City of Portland, Maine – Building or Use Permit Application 389 Congress Street, 04101, Tel: (207) 874-8703, FAX: 874-8716

Location of Construction: #27 Fernald St. Portland 04101		Owner: * Susan Lavigne		Phone: (207) 775-0626		Permit No: 990460	
Owner Address: 27 Fernald St. Portland 04101		Lessee/Buyer's Name:		Phone:		Business Name:	
Contractor Name: Nicol H. Tiffa		Address: 31 Rocky Hill Rd. Saco, Me. 04077		Phone: (207) 284-9149		PERMIT ISSUED MAY 12 1999 CITY OF PORTLAND	
Past Use: 2 Family		Proposed Use: Same		COST OF WORK: \$ 2,000.00		PERMIT FEE: \$ 30.00	
Proposed Project Description: Construct Rear Deck		FIRE DEPT. <input type="checkbox"/> Approved <input type="checkbox"/> Denied		INSPECTION: Use Group: A3 Type: 5B		Zone: CBL: K-3 168-3-005	
		Signature:		Signature: [Signature]		Zoning Approval: 02-3-1/1/99	
		PEDESTRIAN ACTIVITIES DISTRICT (P.A.D.)		Action: <input type="checkbox"/> Approved <input type="checkbox"/> Approved with Conditions <input type="checkbox"/> Denied		Special Zone or Reviews: <input type="checkbox"/> Shoreland <input type="checkbox"/> Wetland <input type="checkbox"/> Flood Zone <input type="checkbox"/> Subdivision <input type="checkbox"/> Site Pla

PROPOSED DECK

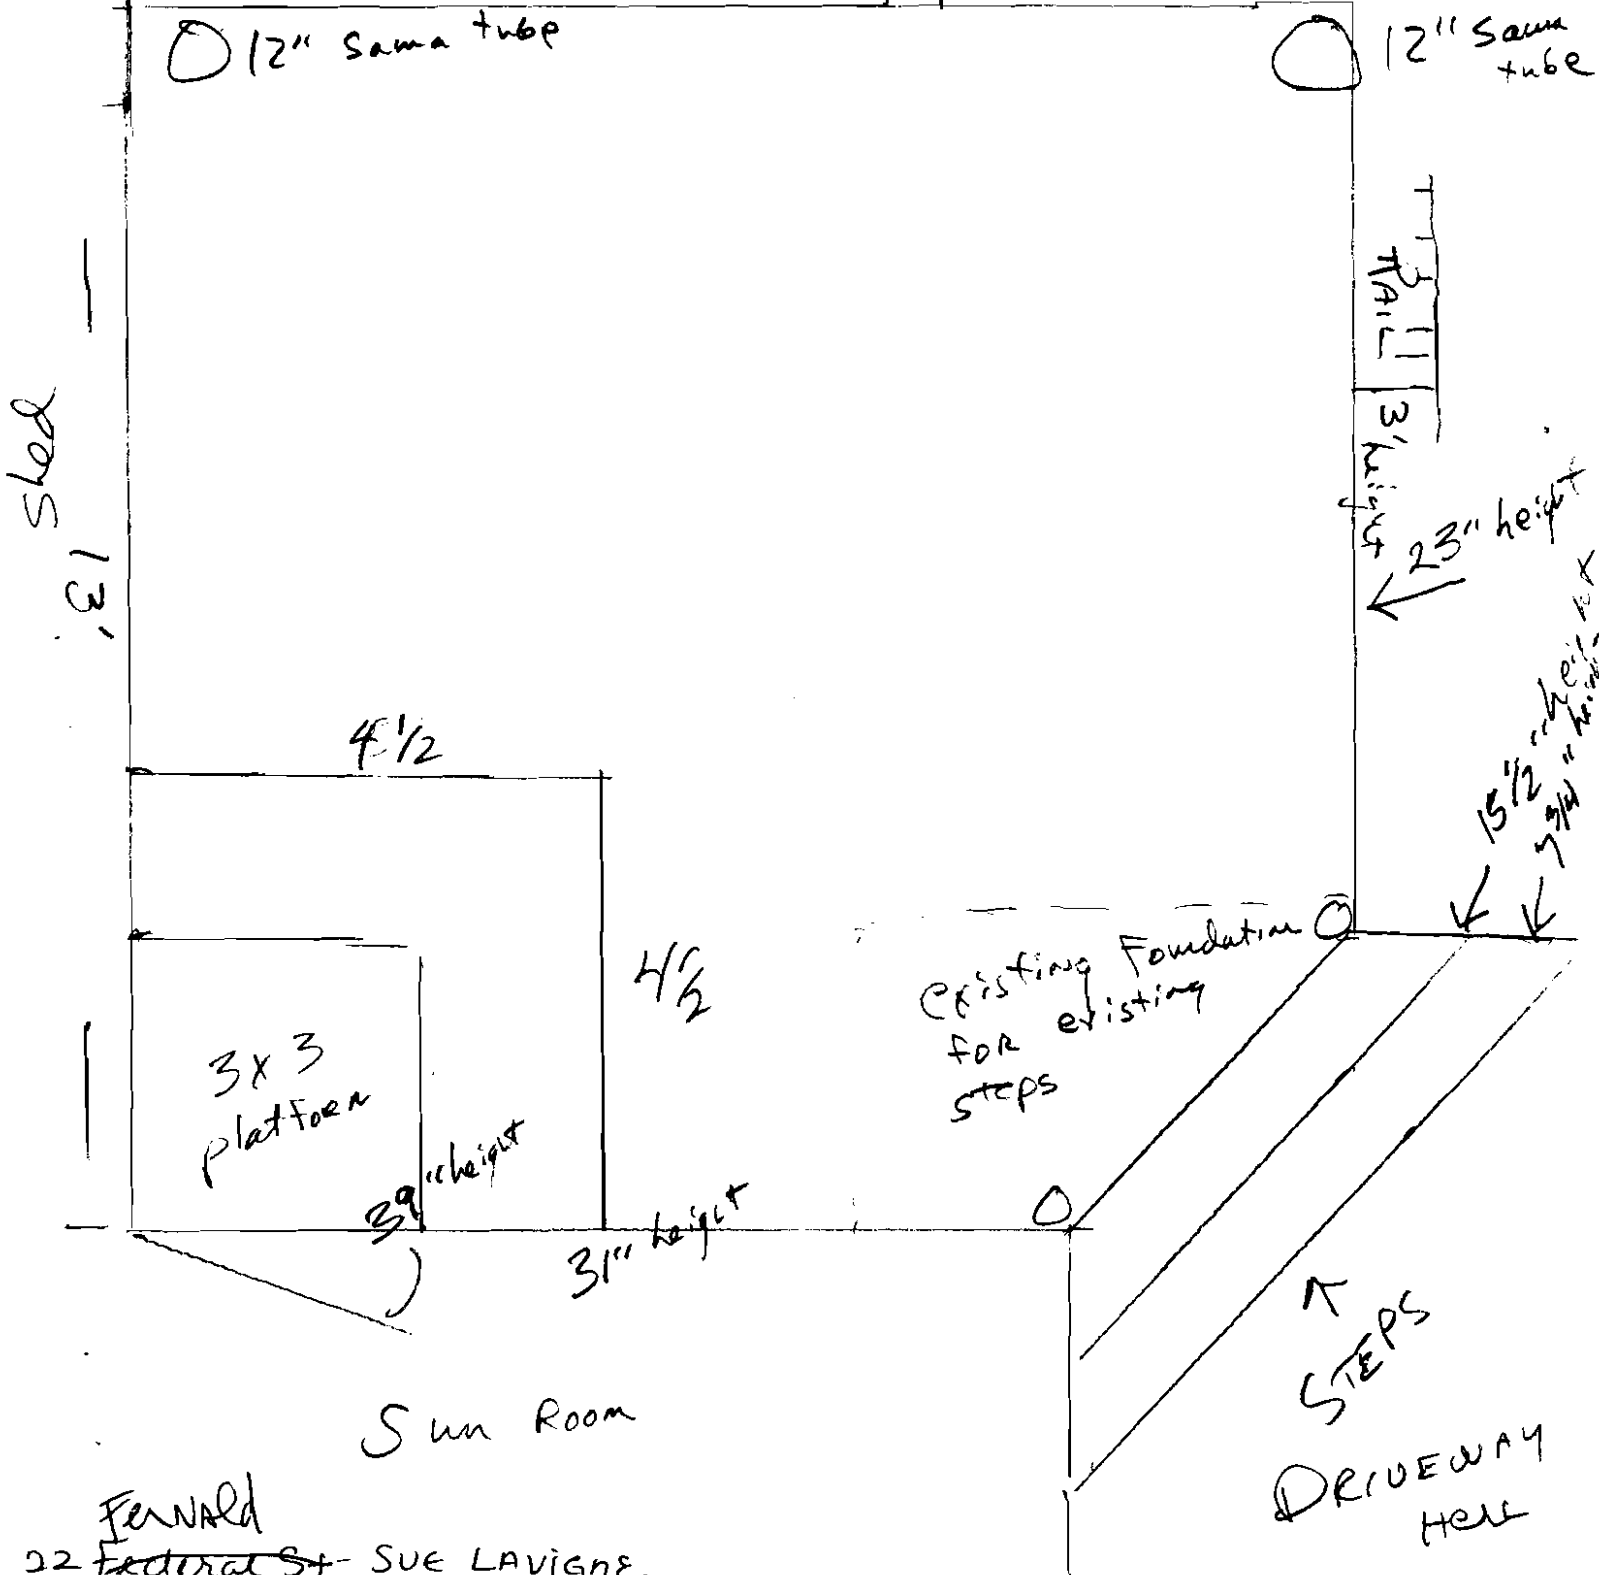
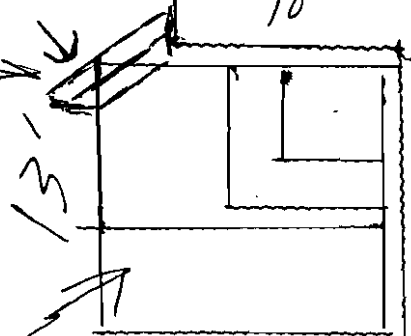
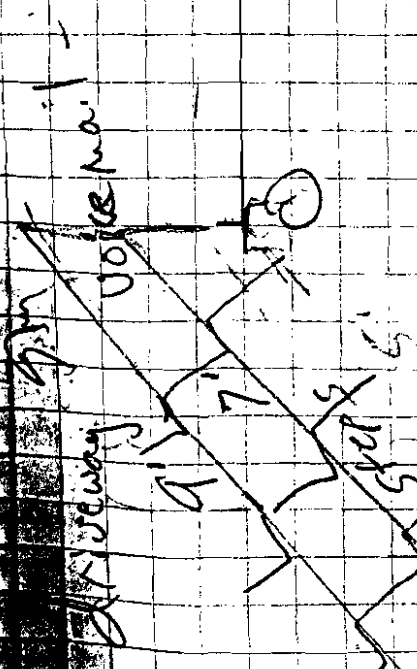
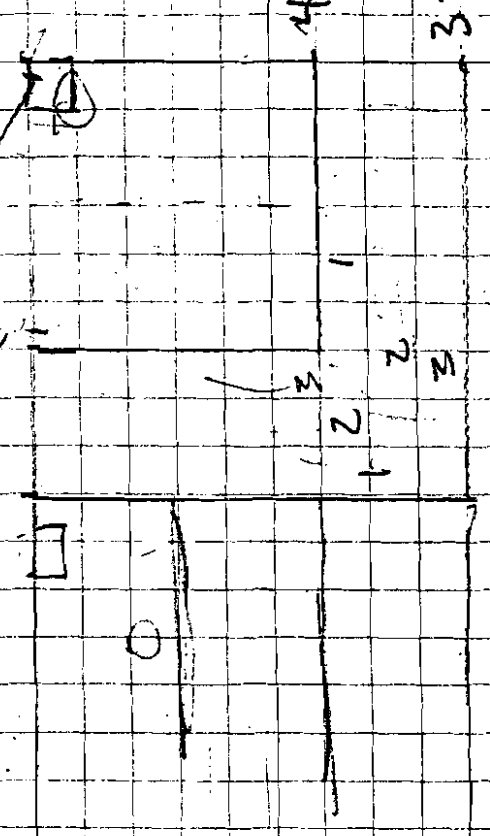
5/19/99 - Met w/ builder on site - sewer tube depth OK -
setbacks OK -

went over conditions - need to use 2x10's for 13' span
builder agreed T.M.
